CITY OF PUYALLUP  
Planning Division Approved Site Plan  
(253) 864-4165  
MINIMUM SETBACK REQUIREMENTS  
Front Yard: 10 ft Rear Yard: 0 ft  
Interior Side Yard: Left: 0 ft Right: 0 ft  
Street Side Yard: N/A  
Zoning District: RM-CORE  
Permit #: PRMU20240279  
Additional Conditions/Comments

Sunset Garden Senior Living Apartments

SITE PLAN

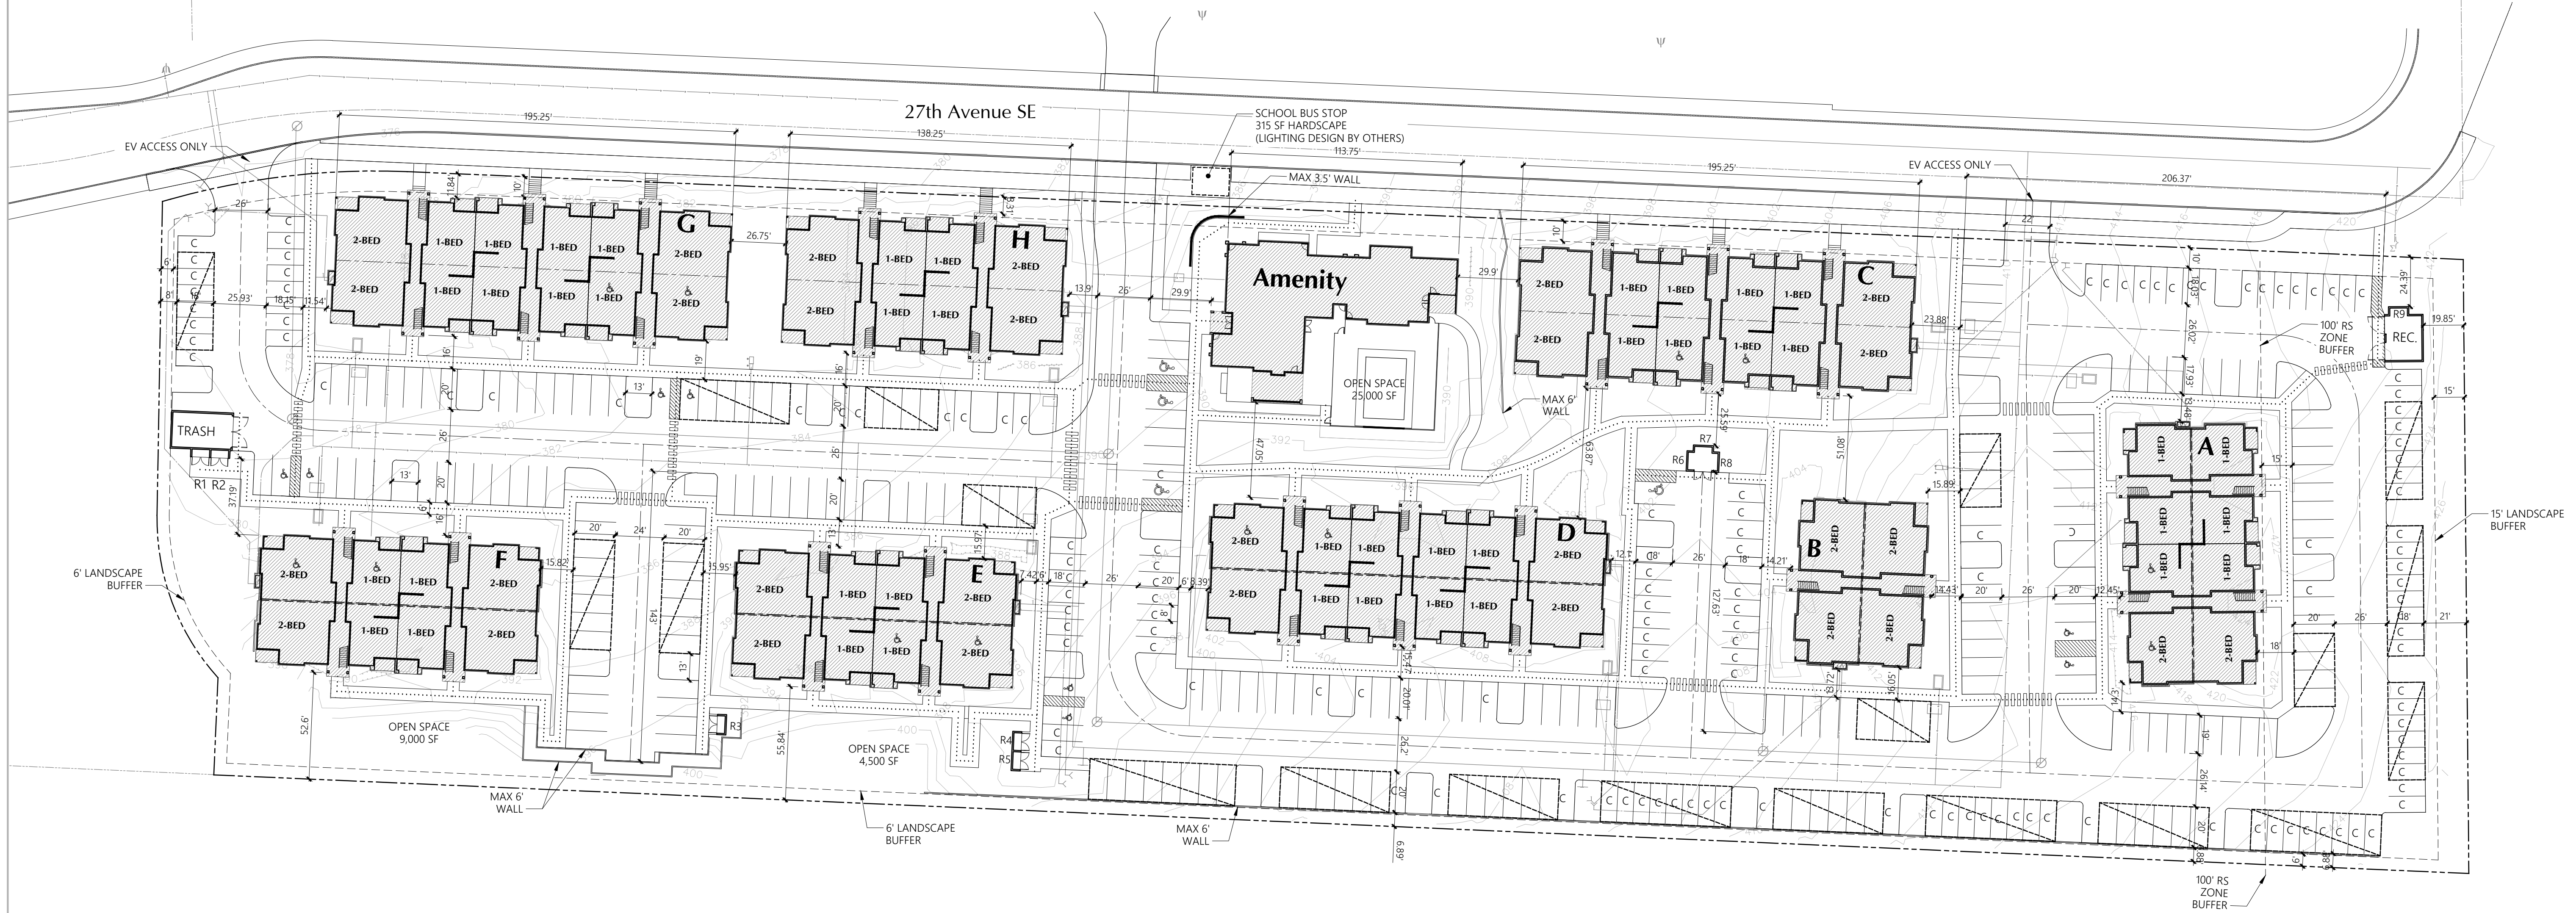
No EV parking calculations included in parking summary.  
Provide EV parking to meet Section 429 of the 2018 IBC WA Amendment.  
Page A2 - Site Plan

Incomplete site plan. Please refer to the CoP Site Plan Standards (available to download in the permitting portal). Revise the site plan to include items 1-3 and items A-X of the City's Site Plan Standards. Since the building permit cannot be issued until civil construction permit is issued first and the building plans must match the approved civil plans, please coordinate your final building permit submittal with the approval of the civil permit to avoid redundant or surplus building permit submittals and fees. [SITE PLAN, sheet A2]

Refer to the PRCNC20240278 corrections and address for all site plans associated with the Bradley Heights Apartments. [SITE PLAN, sheet A2]
